PROJECT ASSESSMENT REPORT			
Unique Document ID and Revision No:	ONR-OFD-PAR-17-003 Revision 0	TRIM Ref:	2017/176884
Project:	Agreement to the modification of the optimisation of inspection requirements on superheater outlet and reheater inlet steam side header welds		
Site:	Dungeness B		
Title:	Agreement to the modification described in Safety Case NP/SC 7749 to Optimise the Inspection Requirements of Welds within the Superheater Outlet Headers and Reheat Inlet Headers on Reactor 21 and Reactor 22 at Dungeness B (Excluding R21 SHO Headers B3 and B8)		
Licence Instrument No: (if applicable)	Agreement 553		
Nuclear Site Licence No:	61		
Licence Condition:	22(1)

Assessment of the optimisation of inspection requirements on superheater outlet and reheater inlet steam side header welds

Agreement to the modification described in Safety Case NP/SC 7749 to Optimise the Inspection Requirements of Welds within the Superheater Outlet Headers and Reheat Inlet Headers on Reactor 21 and Reactor 22 at Dungeness B (Excluding R21 SHO Headers B3 and B8)

Project Assessment Report ONR-OFD-PAR-17-001
Revision 0
26 May 2017

Figure 1 - Position of the headers

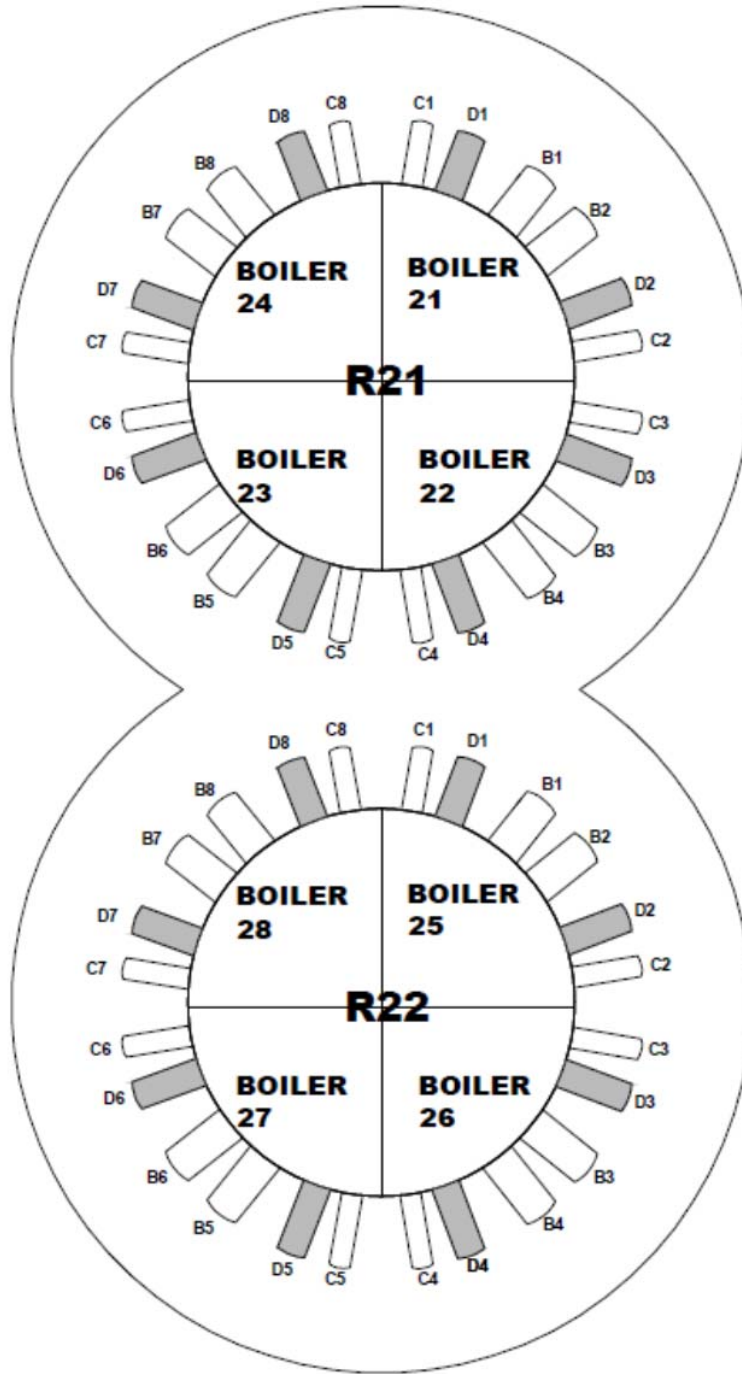
2. Dungeness B has two advanced gas reactors, designated Reactor 21 and Reactor 22. Each reactor has eight superheater outlet (SHO) header penetrations (Figure 1), which provide superheated steam from the boilers to the turbine. They are large welded cylindrical stainless steel vessels (Figure 2). In 1999, routine inspections undertaken by the licensee, EDF Energy Nuclear Generation Limited (NGL), identified a fully circumferential crack in a weld (designated Weld 'A' on Figure 2) on the inside surface of SHO header penetration labelled "B3" (Figure 1) on Reactor 21.

3. NGL attributed the cause of the deterioration to the use of an incorrect weld metal during manufacture. It undertook an extensive inspection and testing programme on welds in all similar components that it considered to be at risk from this form of deterioration. This programme identified one additional weld (Figure 1, B8) in another SHO that had suffered from cracking. NGL subsequently repaired both welds.

Figure 2 - Superheater outlet header

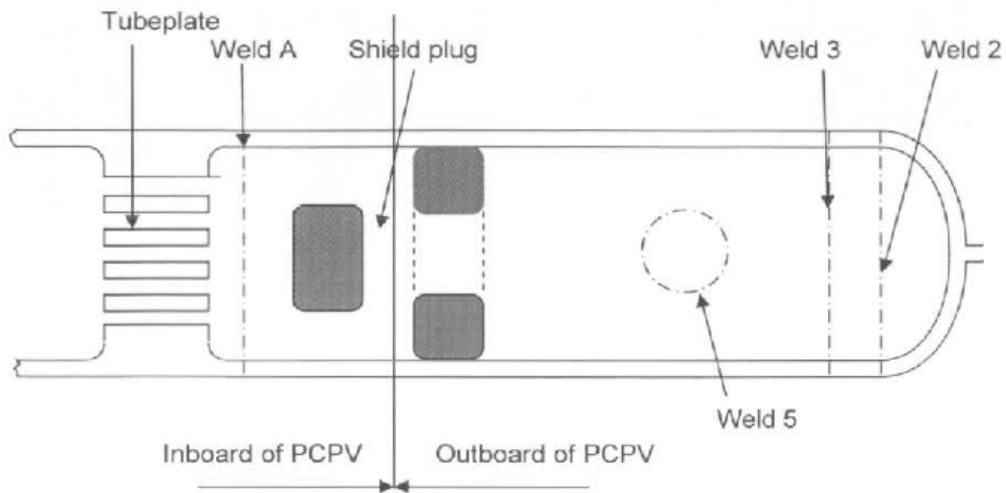
6. The proposal under consideration would remove internal volumetric inspections of the header welds. It would retain external inspection of welds 2, 3 and 5 and a proportion of weld E (as a portion of the weld is encased in the concrete and inaccessible externally). Weld E is an additional axial seam weld only featured on the RHI headers (see Figure 3). Also retained is internal surface inspection of all welds using remote visual inspection technology. NGL accept that this will not have the same capability as identified in the safety case but judge that the technique will detect any significant defects.

7. One weld in particular will have the greatest reduction in inspection and that is weld "A", which no longer needs be inspected volumetrically. NGL consider that it will retain forewarning of failure of all welds apart from weld A and the un-inspected areas of weld E through an external volumetric inspection. Under this proposal, NGL will modify
